## HISTORIC AND DESIGN REVIEW COMMISSION

February 03, 2021

**HDRC CASE NO:** 2021-018  
**ADDRESS:** 223 E CAROLINA ST  
**LEGAL DESCRIPTION:** NCB 3010 BLK 8 LOT 15  
**ZONING:** RM-4, H  
**CITY COUNCIL DIST.:** 1  
**DISTRICT:** Lavaca Historic District  
**APPLICANT:** Alan Yoshida/YOSHIDA ALAN TATSUO & SARAH JO  
**OWNER:** Alan Yoshida/YOSHIDA ALAN TATSUO & SARAH JO  
**TYPE OF WORK:** Front yard fence and landscaping  
**APPLICATION RECEIVED:** January 11, 2021  
**60-DAY REVIEW:** Not applicable due to City Council Emergency Orders  
**CASE MANAGER:** Huy Pham  
**REQUEST:**

The applicant is requesting a Certificate of Appropriateness for approval to:

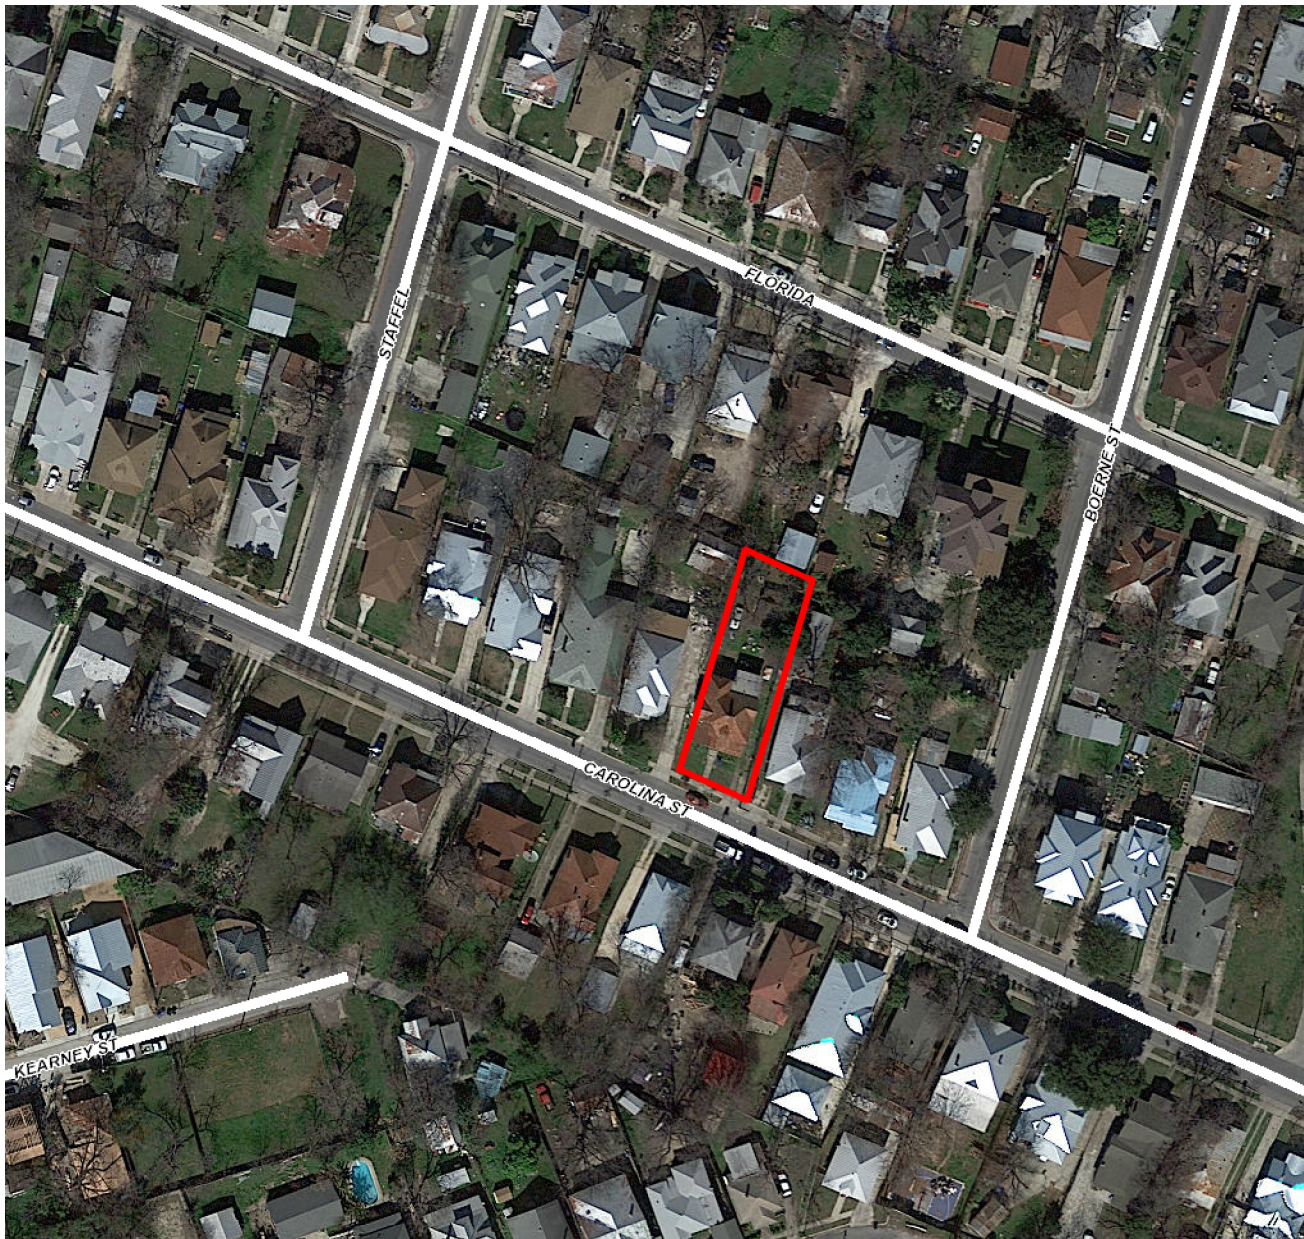
- The primary structure located at 223 E Carolina is a 1-story single family structure constructed circa 1925 in the Folk Victorian style. The structure features woodlap siding, an asymmetrical front porch, a metal roofing, and wood windows. The structure is contributing to the Lavaca Historic District.
- XERISCAPING** – The applicant has proposed to modify the existing grass lawn with xeriscaping including an organic-shaped granite path over river rock beds with boulders, aloe vera, agave, desert spoon, and an oak tree. Per the Guidelines for Site Elements 7.A.ii., applicants should not fully remove and replace traditional lawn areas

with impervious hardscape. Limit the removal of lawn areas to mulched planting beds or pervious hardscapes in locations where they would historically be found, such as along fences, walkways, or drives. Low-growing plantings should be used in historic lawn areas; invasive or large-scale species should be avoided. Historic lawn areas should never be reduced by more than 50%. In addition to the proposed individual xeric plants, staff recommends reintroducing areas of natural lawn or low-growing plant cover to meet the majority plant cover requirement. Per the Guidelines 7.A.iii., staff also recommends the applicant refer to UDC Appendix E: San Antonio Recommended Plant List—All Suited to Xeriscape Planting Methods.

- c. GARDEN FENCE – The applicant has proposed to install a low metal garden fence around the perimeter of the front yard excluding the driveway. Staff finds that fences are found in the Lavaca district on similar style structures and is appropriate.

Staff recommends approval of item 1 and 2 based on the findings with the stipulation reintroducing areas of natural lawn or low-growing plant cover to meet the majority plant cover requirement by referring to the UDC Appendix E: San Antonio Recommended Plant List—All Suited to Xeriscape Planting Methods. A revised plan including the final fence design must be submitted to staff prior to issuance of a Certificate of Appropriateness.
